RE: NPDES Compliance Inspection, Marion Wastewater Treatment Plant

AFIN: 18-00110 NPDES Permit No.: AR0021971

RE: NPDES Compliance Inspection, Marion Wastewater Treatment Plant

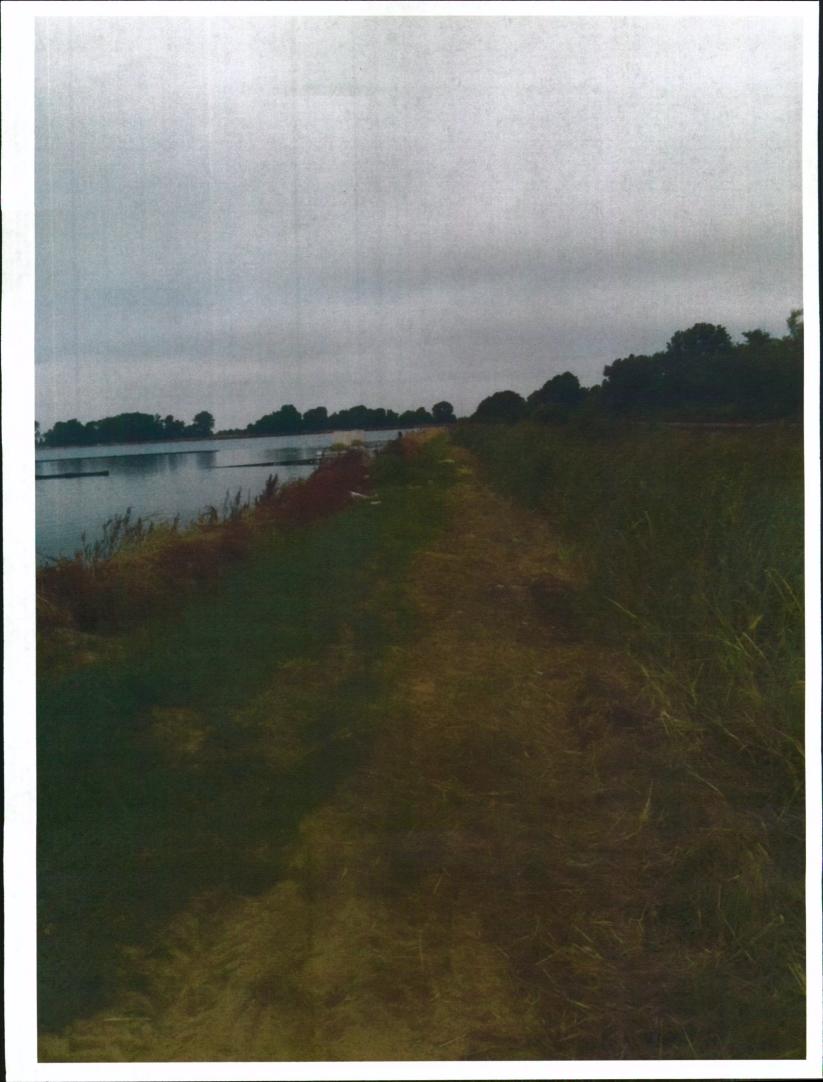
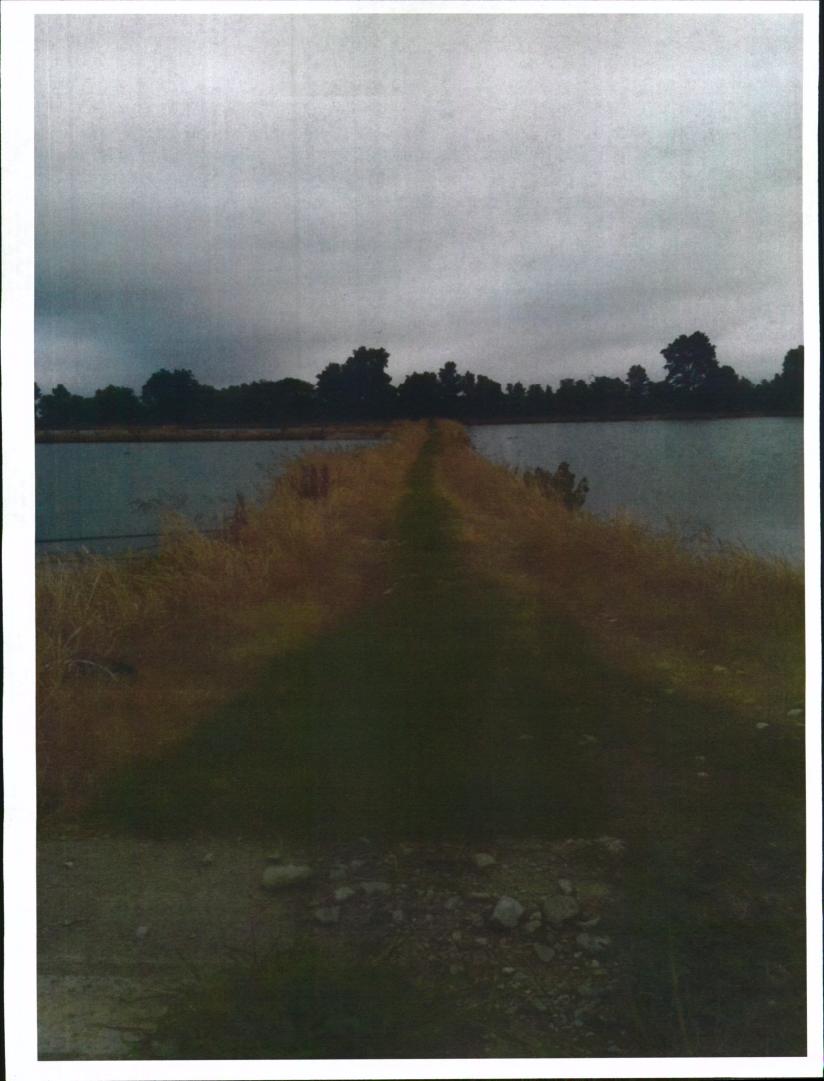
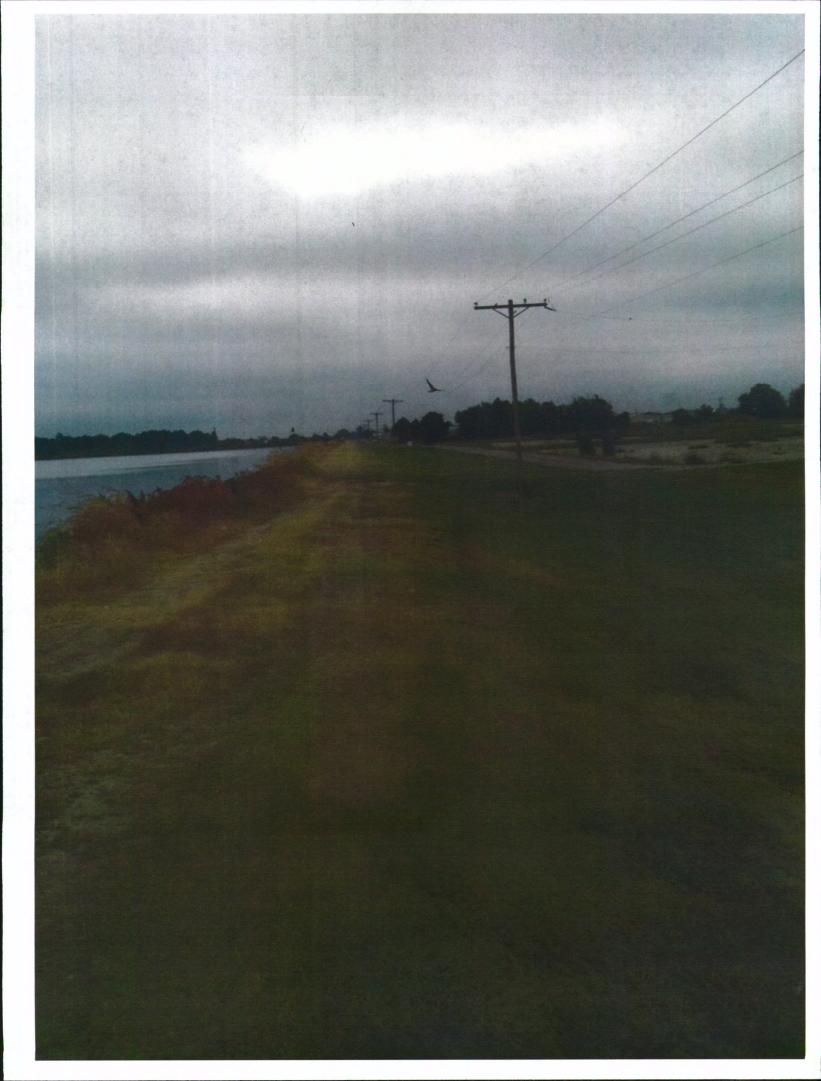
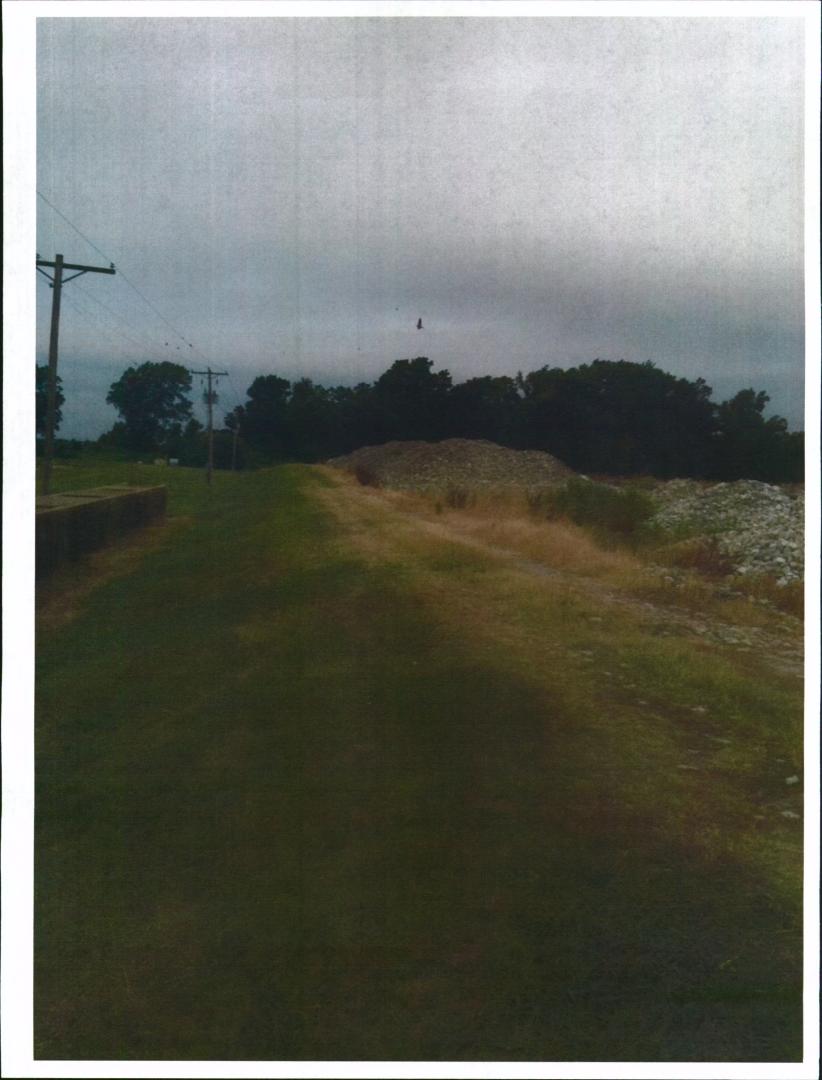
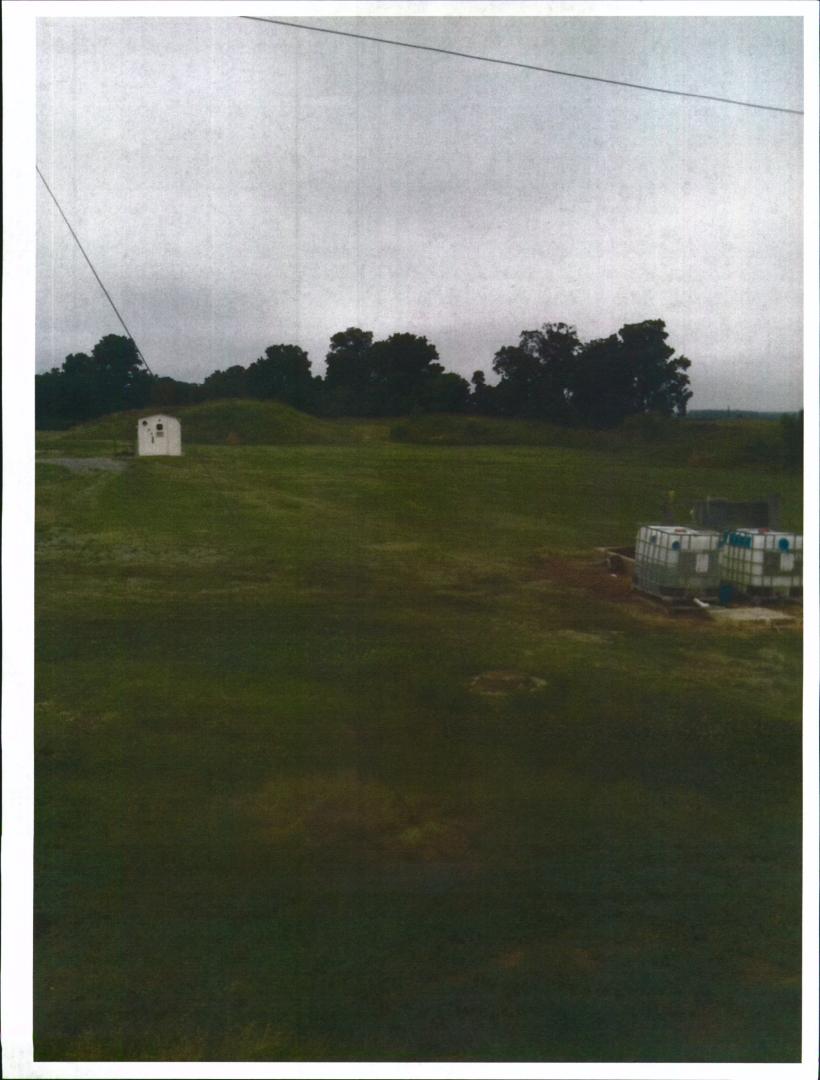
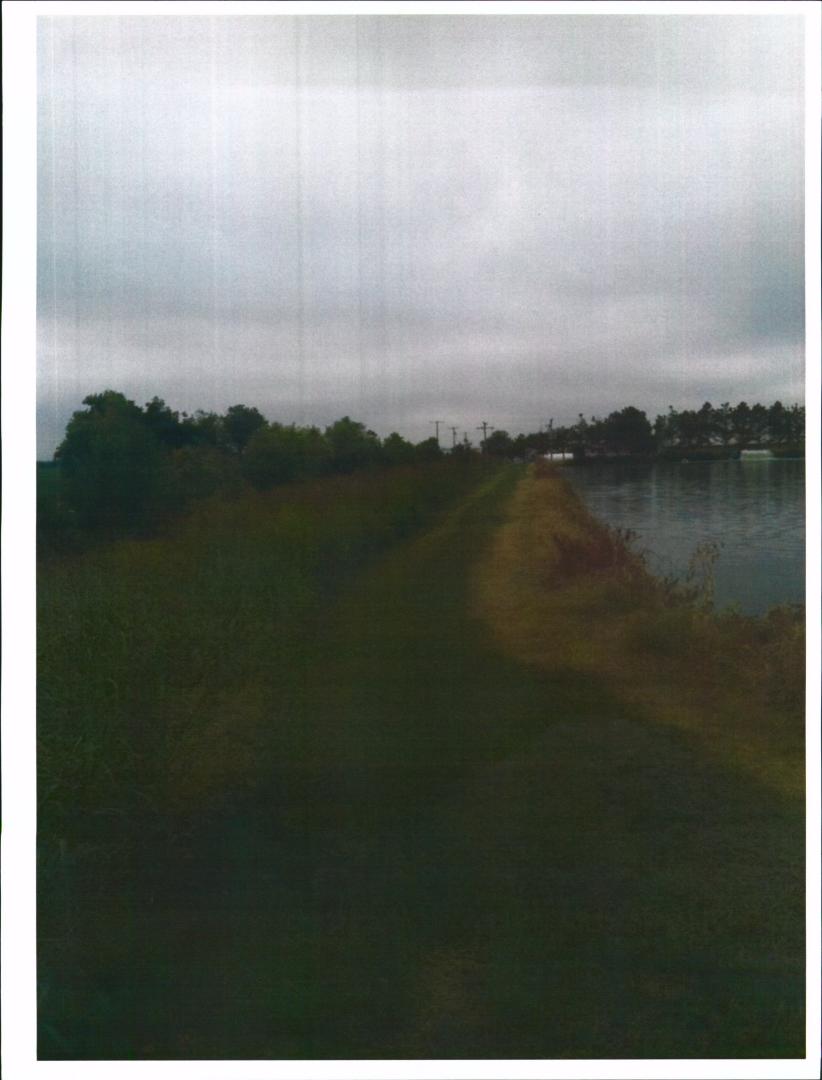
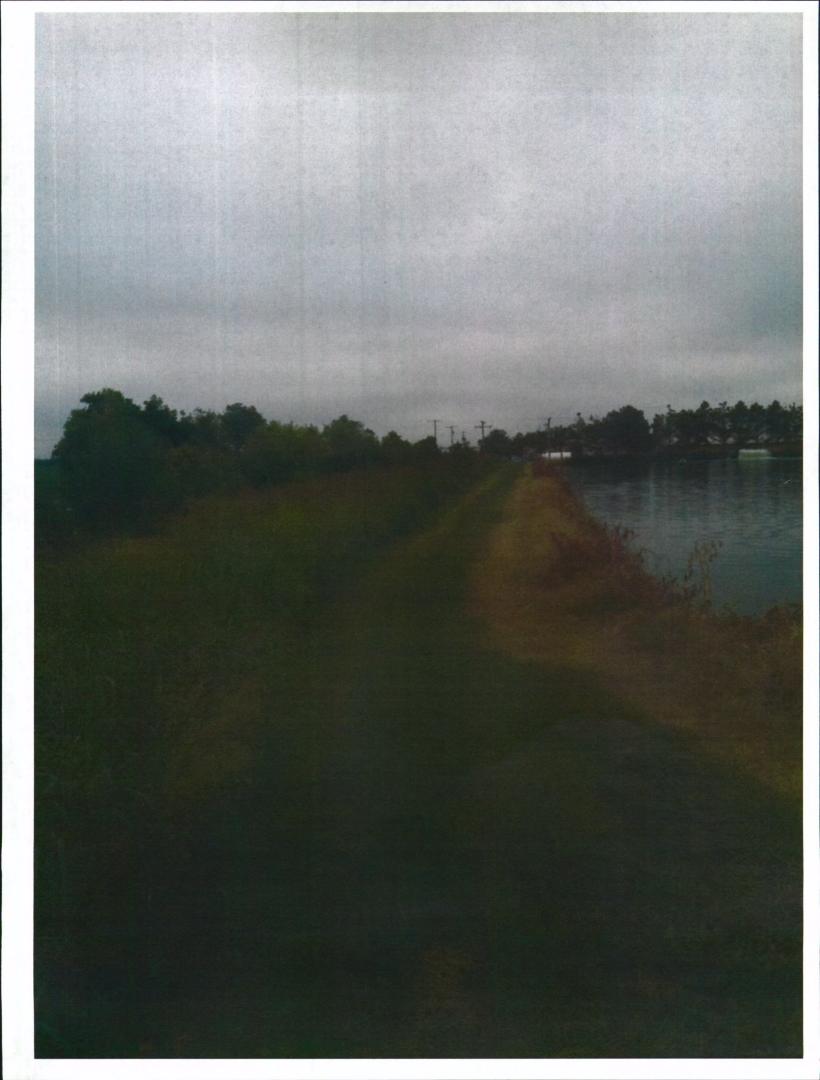
- 1. Improper operation and maintenance. This violates Part II, Section B., Item 1.a. of the permit, which requires that the permittee shall at all times properly operate and maintain all facilities and systems of treatment and control (and related appurtenances)which are installed or used by the permittee to achieve compliance with the conditions of this permit. The following items were noted:
 - a) There was excessive growth of vegetation on the lagoon levees.
 - b) Reeds were not adequately maintained in the rock reed filters.
 - c) The exhaust fan was not operational in the chlorine room.

- 1. Excessive grease and solids were in the wet well of the St. John pump station.
- 2. There was not an adequate alarm system or emergency contact information posted at many of the pump stations visited during this inspection.

- 1. Operation and Maintenance.
- a) The City of Marion purchased a new tractor and bushhog mower the week following this recent inspection, and has made great strides in removing the excessive vegetation on the levees, with some additional work still to be done.
- b) In response to the Reed situation on the rock beds, we are currently accessing the effectiveness of the Rock Reed Filters on our final effluent, in collaboration with our engineers on our recent (CAO).
- c) A new exhaust fan will be purchased and installed in our chlorine room in a timely fashion.

- 1. Grease and solids have been removed from this lift station. (St. John)
- 2. We have received two quotes from electricians for these alarms; these too will be installed in a timely fashion.
